Historic District Review Board

Regular Session Agenda

October 18, 2011

From: Tom Bonadeo
Date: October 18, 2011
Item: 4A – 102 Madison Avenue – rear addition to the home
Attachments: Plans

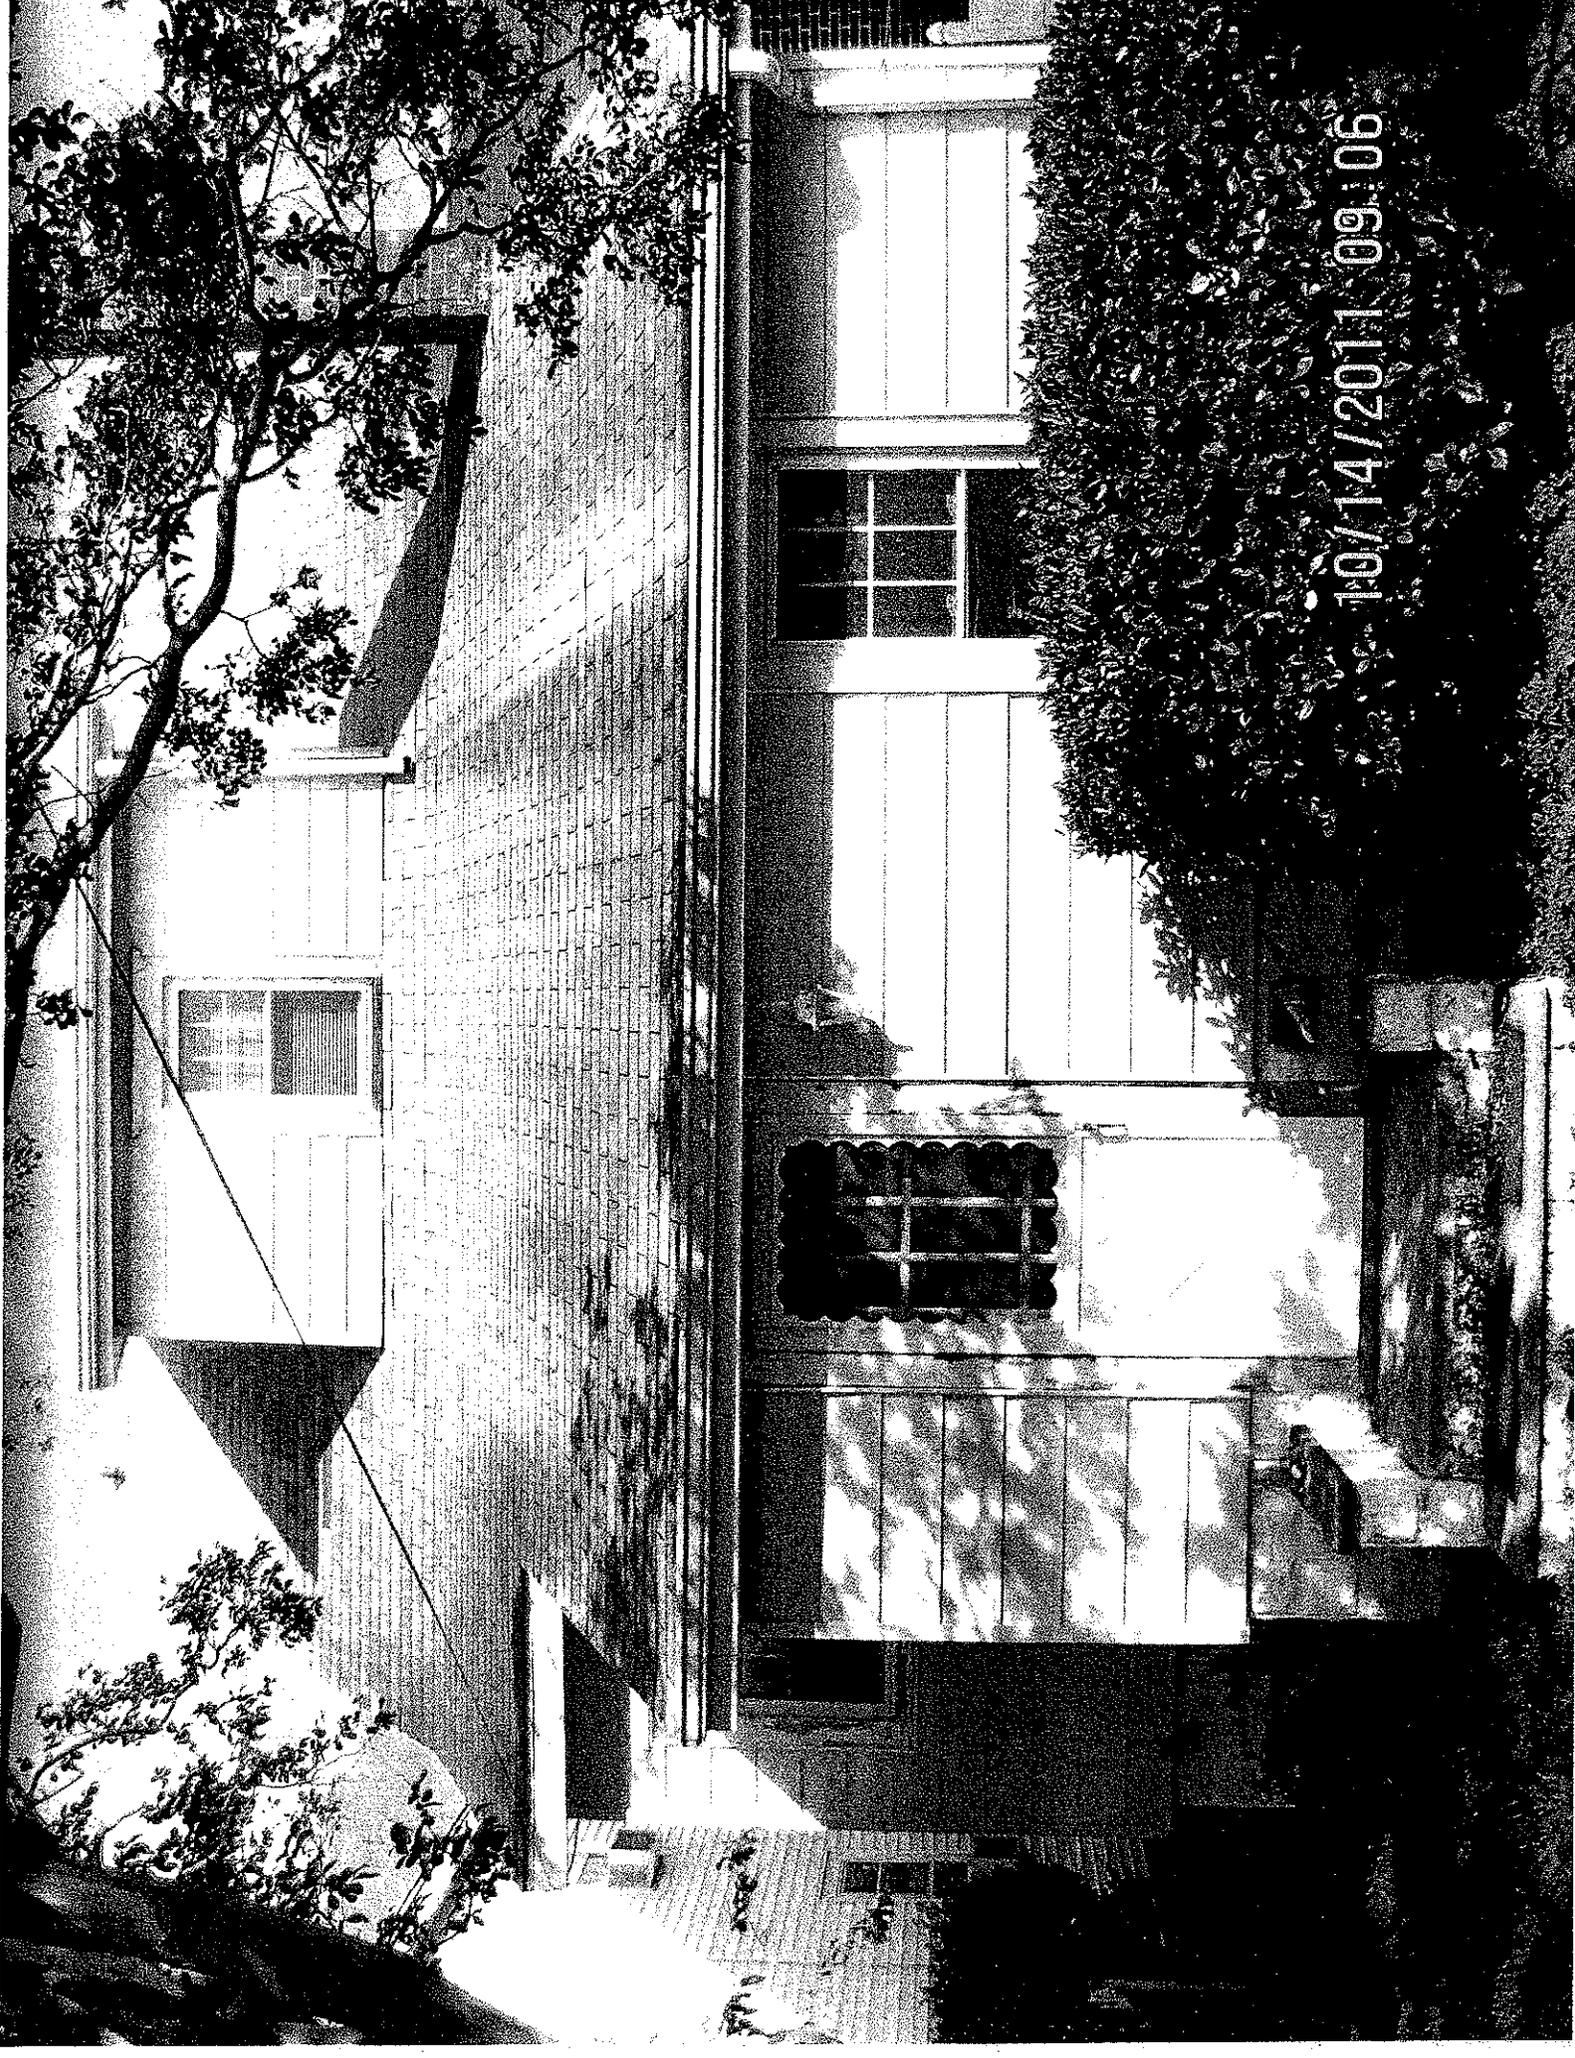
While the addition is the center of the application, the siding and roofing of the main house will also be replaced. The following items will be considered:

1. The roof of the new structure will be architectural shingles.
2. The roof of the existing house will be replaced with matching shingles. The roof condition can be seen from the photo.
3. The siding on the new addition will be Hardi Plank siding with a 5" exposure.
4. The aluminum siding on the existing structure will be replaced with matching Hardi Plank. Aluminum siding is listed in the ordinance as "visually intrusive".
5. New windows in the addition will match the existing house.
6. The foundation is specified as "sprit faced block to match original".

The application generally meets the requirements of the ordinance. The materials are generally compliant with the historic guidelines and the setbacks and other zoning requirements are also met. The application does specify the split faced block that our ordinance does not specifically address. The ordinance does not allow exposed concrete block above the foundation. In this case the original foundation is the old molded concrete block that is painted. Staff recommends that this split face be painted or parged and painted.

Staff recommends the approval of the addition, roof and siding replacement with the recommendation that the split face block foundation be painted and/or parged.
